### STAFF REPORT

Re: Application FS2017-02, Inland Port IX, Final Site Plan for Logistics Park Kansas City

Phase VI, Second Plat, Lot 1, located along the north side of 183<sup>rd</sup> Street just east of

Re: Application FS 2017-05, Final Site Plan for Dollar General, located on the south side of

A1.00 OVERALL FLOOR PLAN

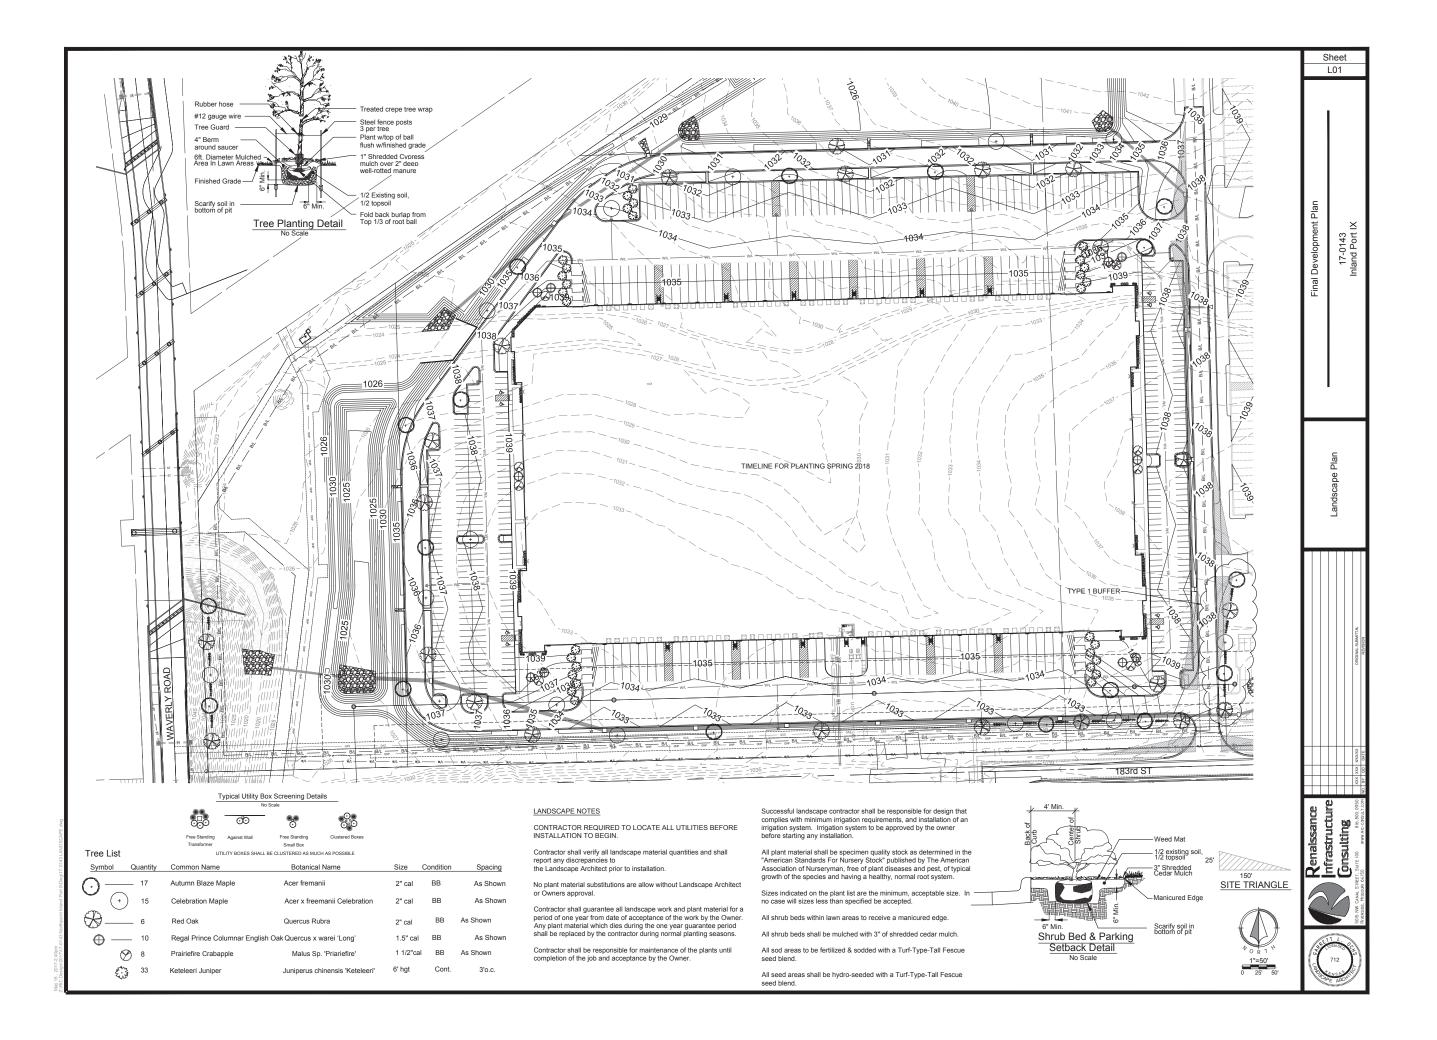
### 1. Sheet A1.00 (page #9)

a) Scale drawings of all building elevations. *Building elevations for the east and west side have not been furnished. Update Final Site Plan.*

Side Elevation

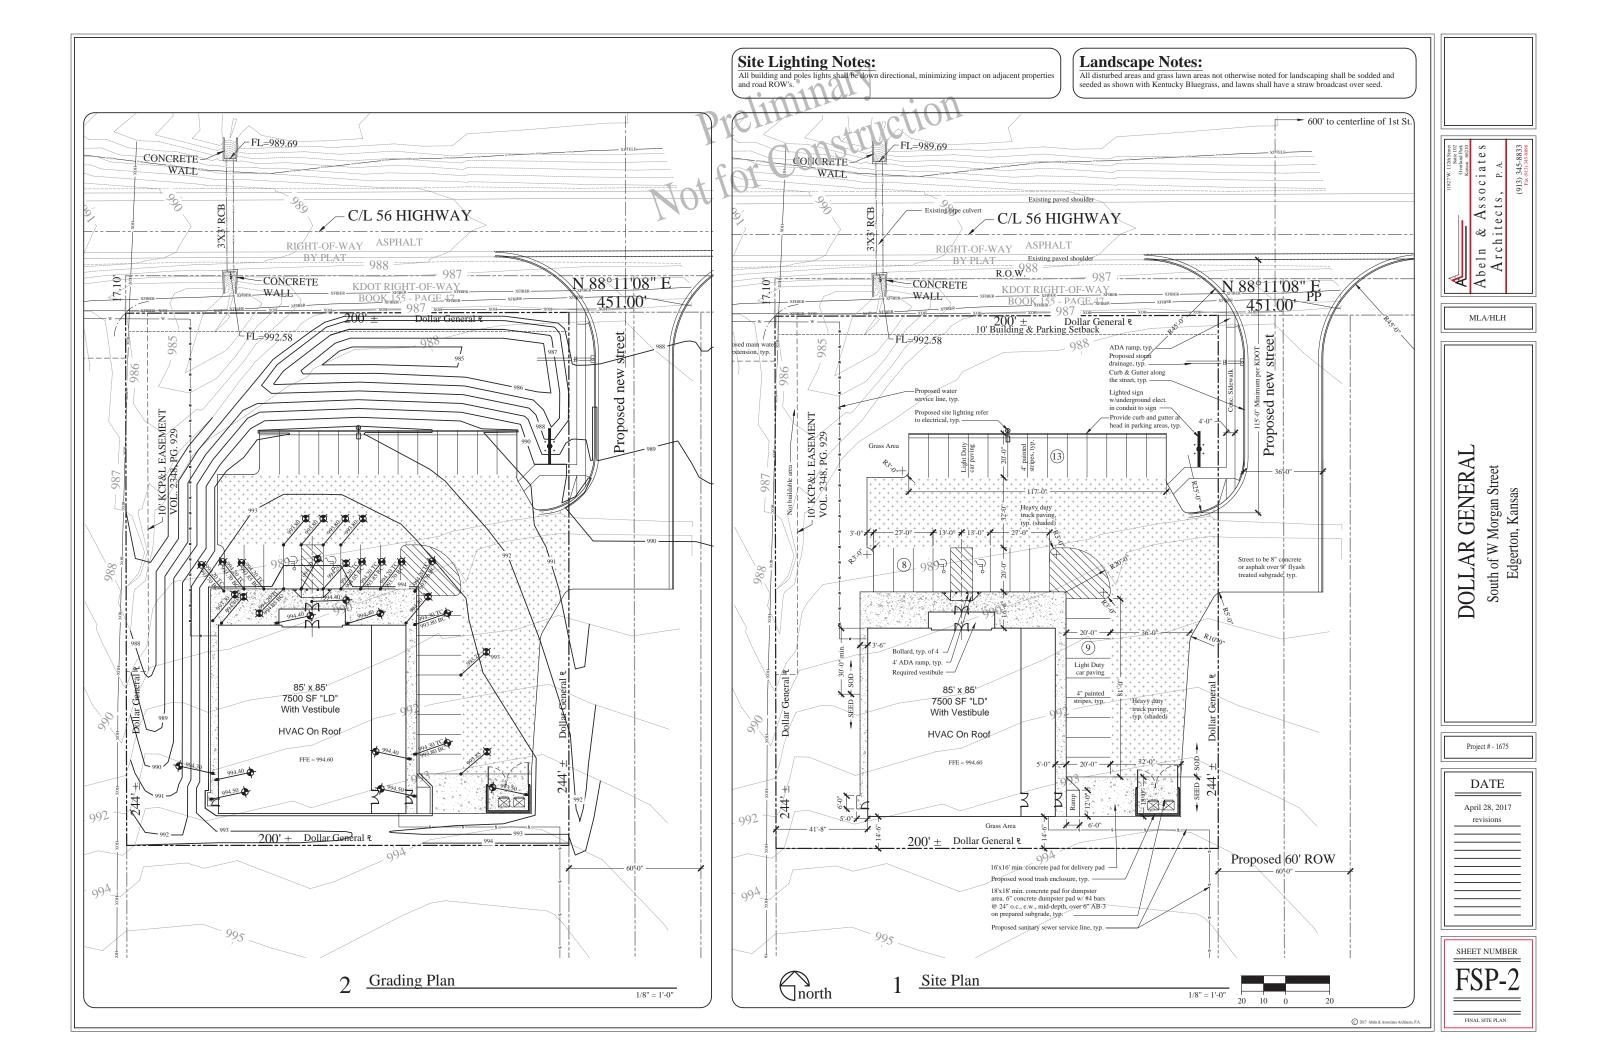
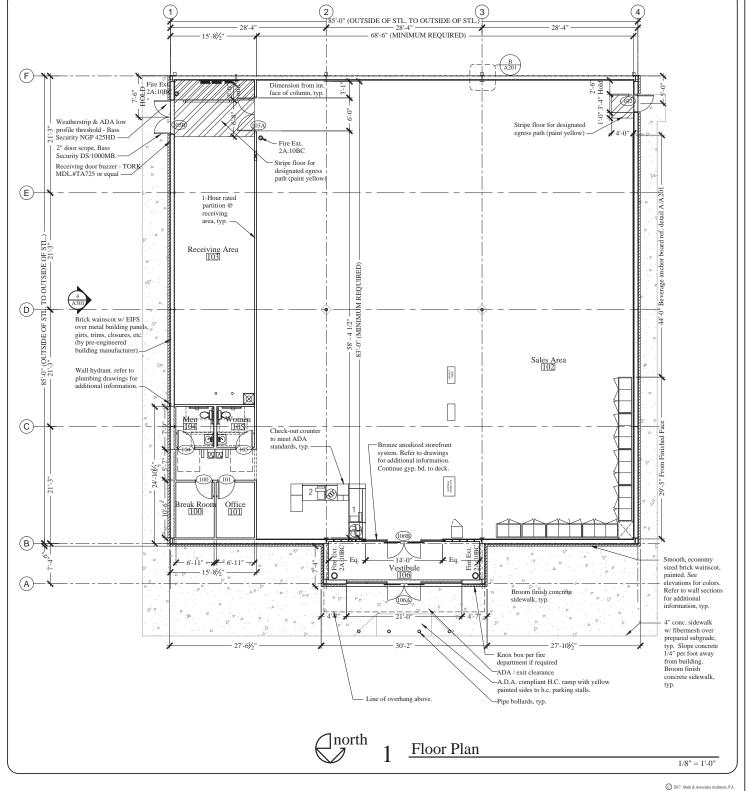
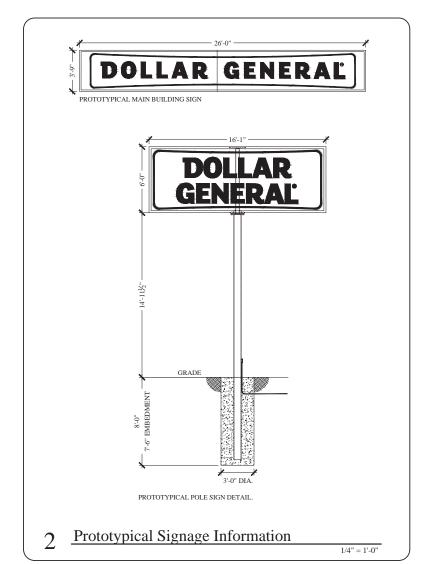
- Exterior walls on the north, east and west sides are proposed to have an EIFS (exterior insulation finishing system) surface with 4 feet of brick along the bottom. Additional information is needed regarding the long-term maintenance and appearance of this material. Additional information regarding economy brick would like to be seen and if acceptable the material extended higher up the exterior walls.

- The south exterior wall is proposed to be all metal. The building orientation on a corner lot would place the rear of the building in general view of future development. C-1 Zoning District regulations provides discretionary authority for the city staff and planning commission to require fascia (surface covering material) for exterior walls. Given that the vacant property to the south could have residential uses in the future, and the building orientations on a corner lot,

- staff recommends the City require the south wall have the same materials as the rest of the building.
- A wood trash enclosure is proposed. The location of the enclosure does not permit the southernmost parking space adequate space to back out. The enclosure shall be constructed of the same materials as the building. **Update** Final Site Plan.

- 11. HVAC rooftop units shall be screened from view with parapets or other architectural design features so as not visible from street rights-of-ways nor residentially zoned property. **Update Architectural Elevations Drawings**.
